SCHEME FOR MCC 5A
SEAFORTH GRAIN TERMINAL

DEWHURST & PARTNER LTD
MELBOURNE WORKS HOUNSLOW

TITLE—
SCHEME FOR MCC 5A - SEAFORTH GRAIN TERMINAL

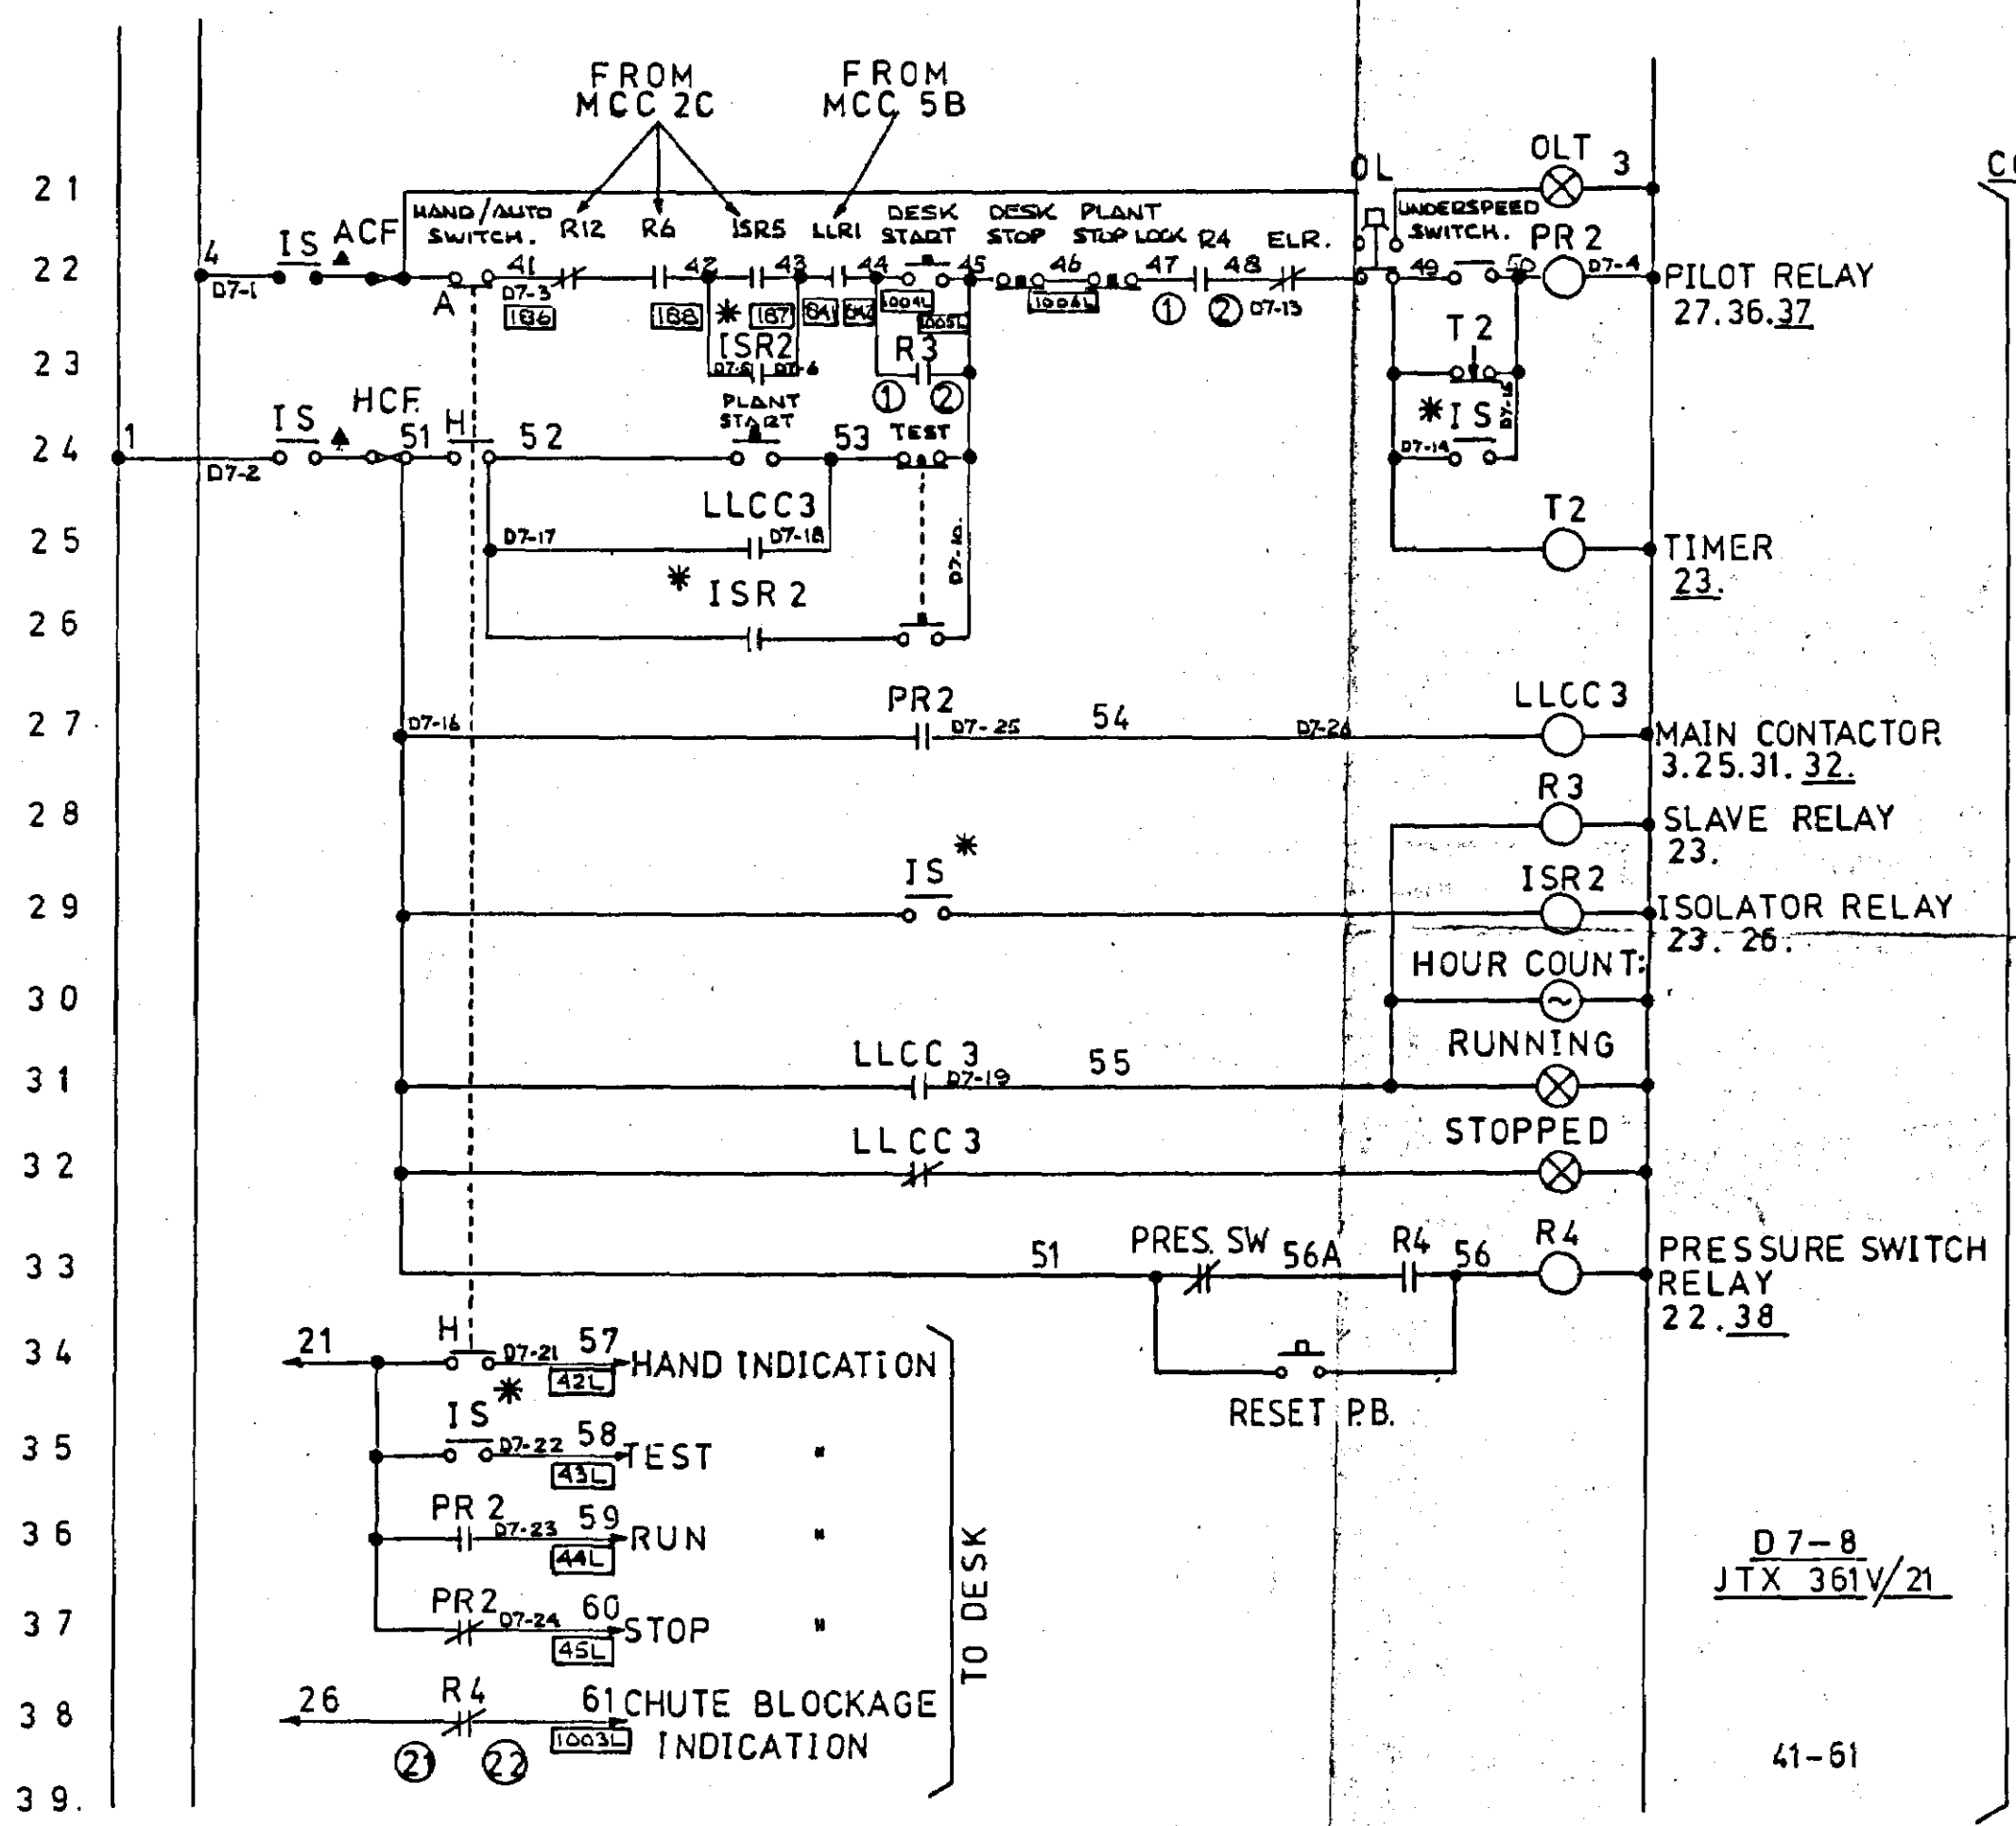
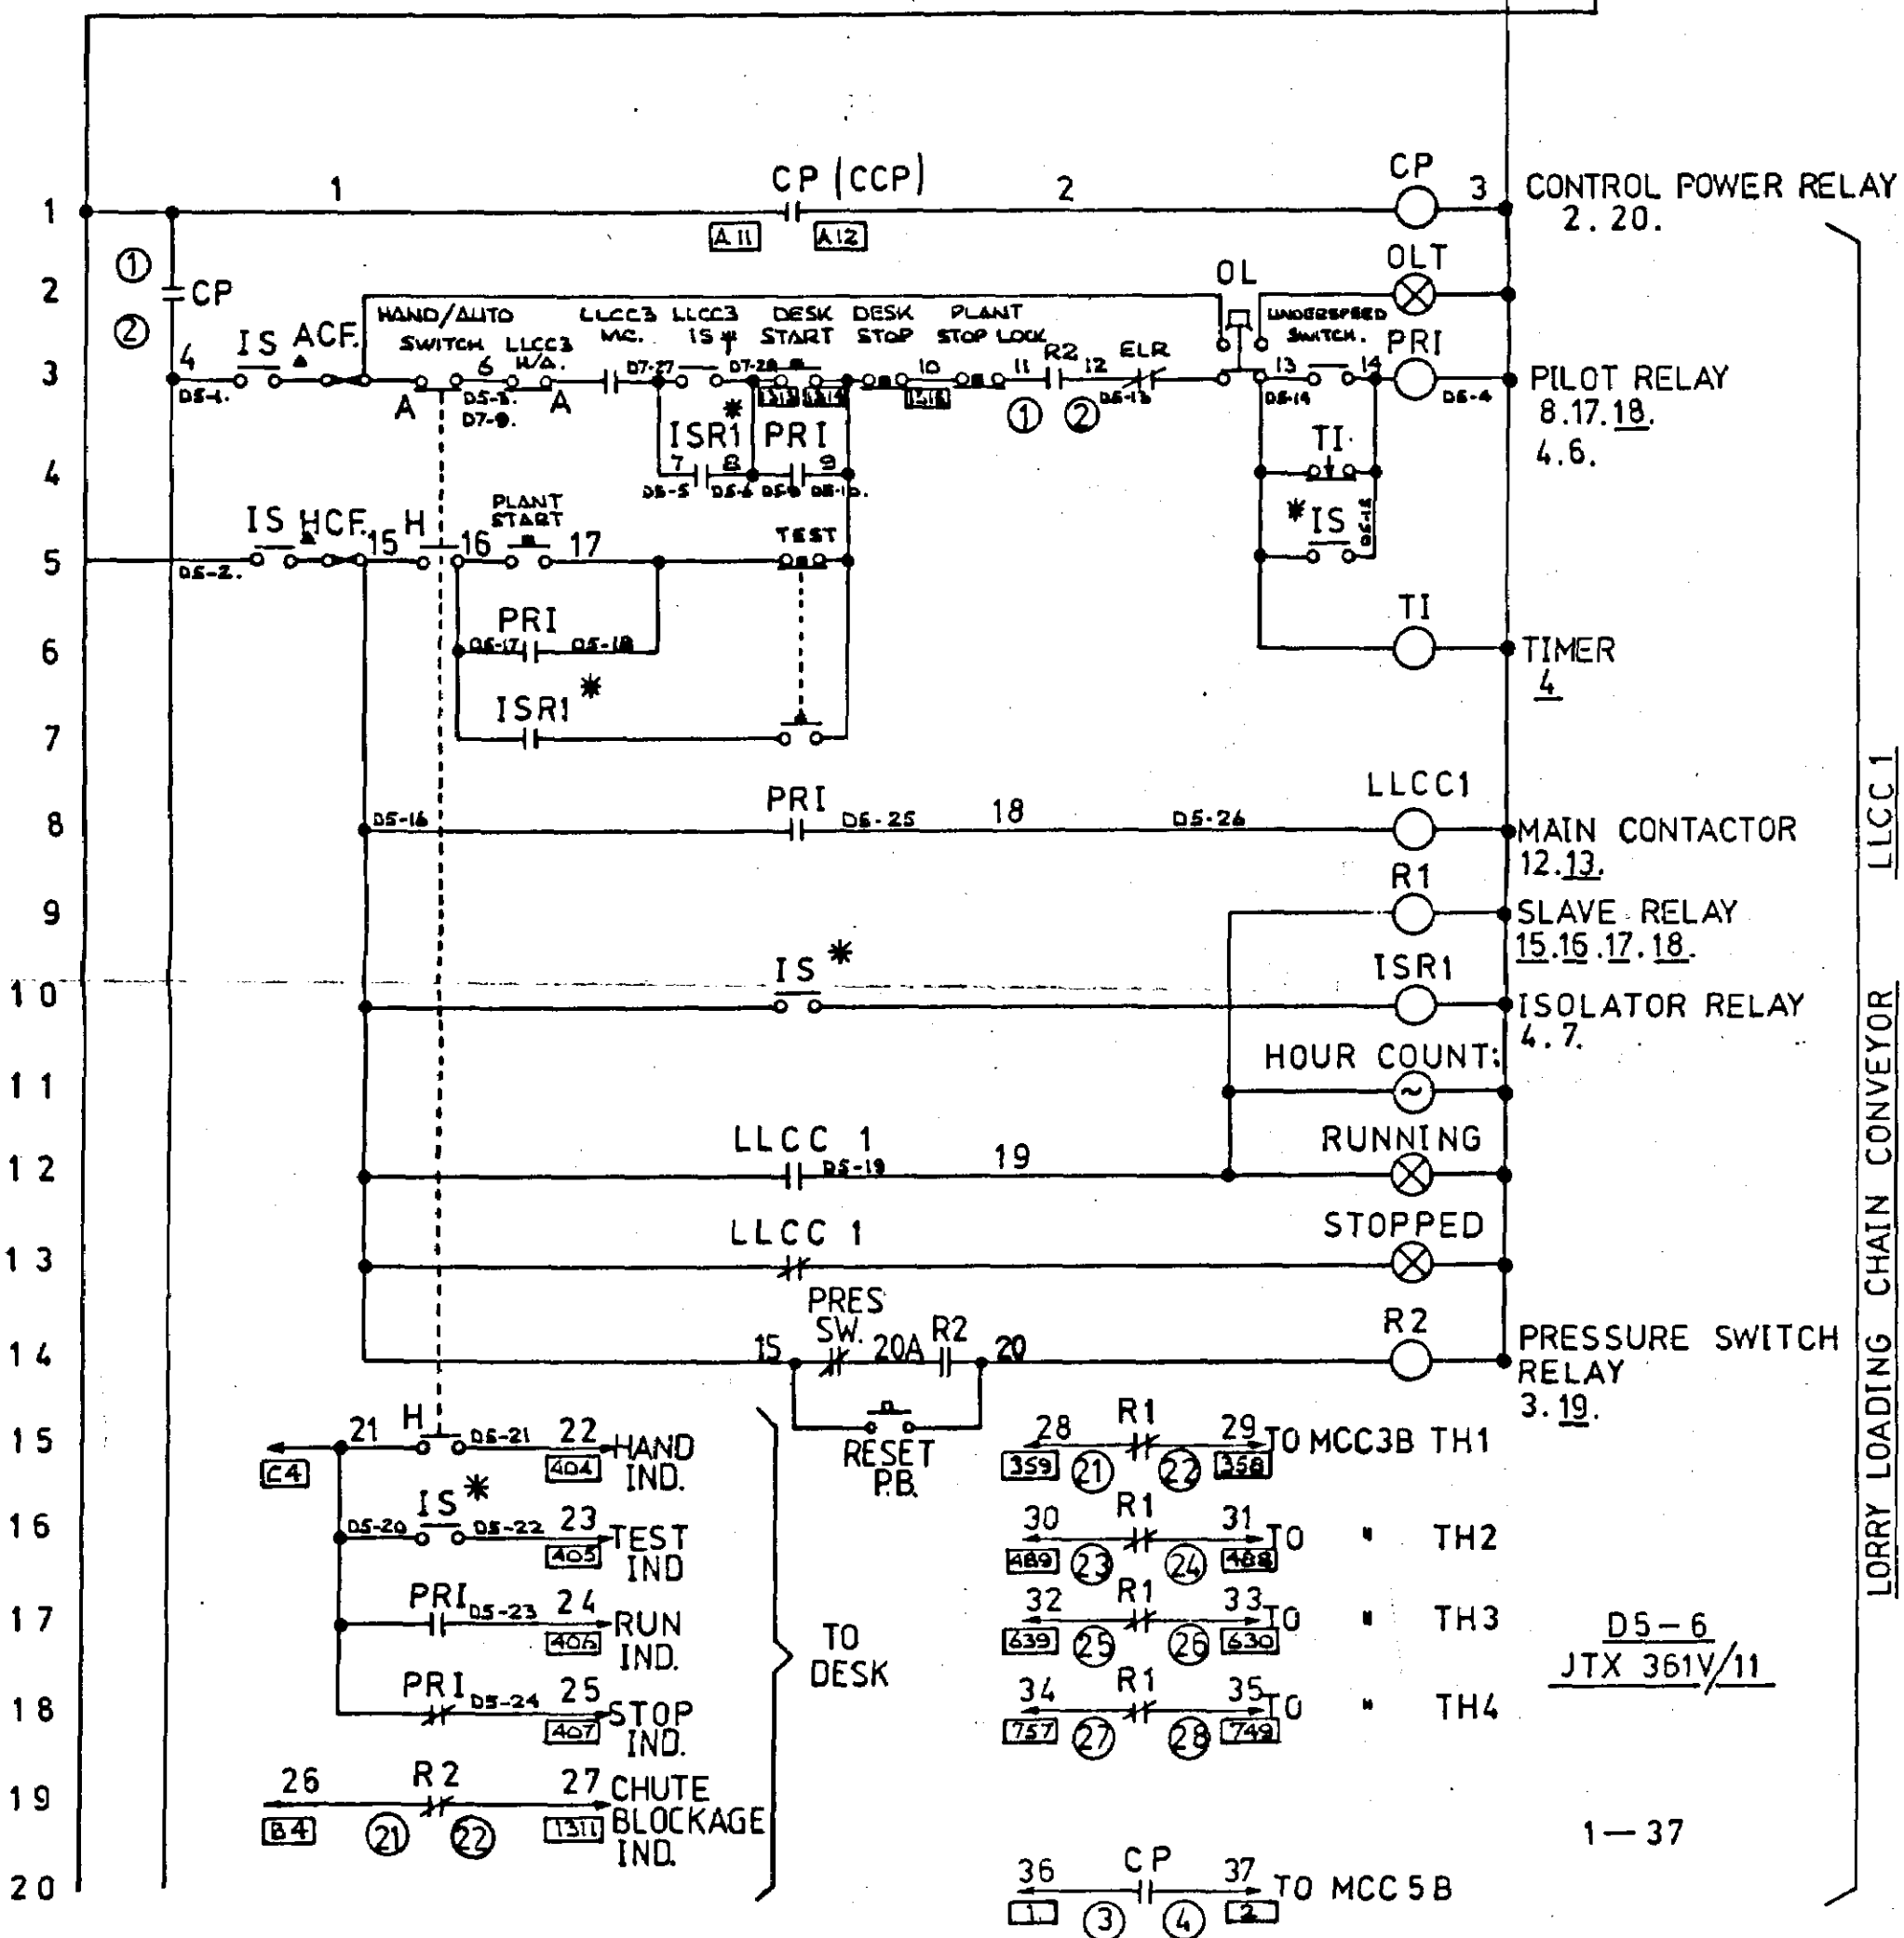
REVISION 3 Line 14: R2 contact & reset PB added Line 33: R4 contact & reset PB added 16-7-81 R.M.N.	REVISION 2 R1 & R2 WERE ACROSS MAIN CONT: COILS 27-5-71	REVISION 1 LLCC1. SUSTAINING CONTACTS WERE ON MC. 20-4-71
--	---	---
